## IEEE P802.11

#### Title: Ballot result Recommendations August/September 1994 session

**Date:** November 3, 1994

RE: 802.11 Ballot due before October 19 -- 11 Motions  
Comments and explanation of NO votes  
Recommended changes

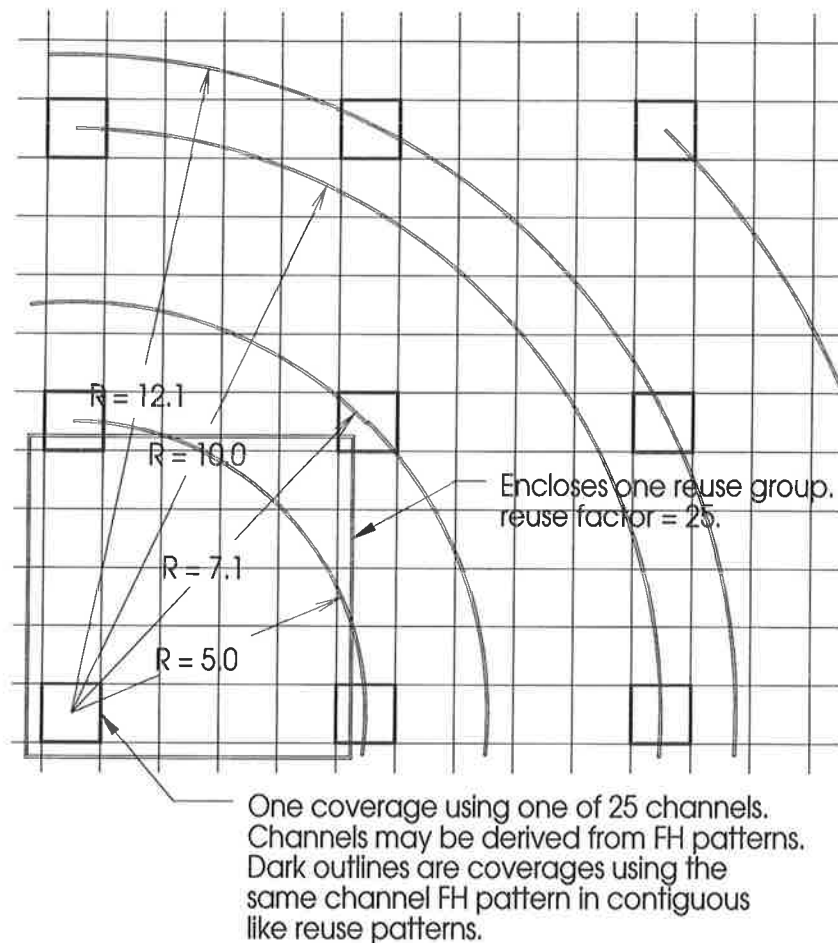
Applied to the current case, it would be found that an FH PHY in which the available channels were used to obtain 100% area coverage requires a reuse factor of at least 36 and probably 49 or 64--the is only a distance increase of 1.2, 1.4 and 1.6 times between independent co-users of the same pattern. The 22 available channels would have to be used more than once within the interference range defined by less than 10% decrease in capacity from each cluster at the edge of the range. This requirement will spend the available channels for frequency reuse before they can be used for overlaid systems.

To illustrate, clusters are spaced in a square pattern of 25 to stay requiring reuse of some of the 22 available channels at closer spacing.. Extrapolating and adjusting the Diepstraten simulation for DS for less interference resistance, the carried traffic would drop to 20% of standalone for one interfering cluster (double the DS value). This neglects the loss from three channels outside of the plan.

The four closest interferers (for DS modulation) together will cause a worst case loss of 80% of the capacity of each coverage in a continuous pattern. Since some of the time two or more interfering transmitters may be on at the same time, and the capacity may only be lost once; the capacity loss might be more like 40%.

In this instance, the clusters at greater distances cannot be neglected. At the distance where each cluster-pair causes a 4-6% loss of capacity in each, there are 16 coverages. Beyond the 4 interior coverages, there are 12 more coverages which are 11-13 dB down from the interior ring of interferers (at path loss average for cluttered environment--less unobstructed). A drawing of the model for this case is shown below.

The dimension  $R$ , shown is the approximate radius of the service area. As a ratio to the radius of the service area, the interference range increases with narrowband modulations relative to spread spectrum. This is why the spectrum efficiency of DS is greater than that estimated with simple spectrum occupancy ratios.

A cluster in the  $R=10$  ring is estimated to reduce capacity by about 5%. Together the outer 12 may cost the central cluster 20-30% of its capacity. The  $R = 7.1$  ring with 4 coverages may take another 20%.
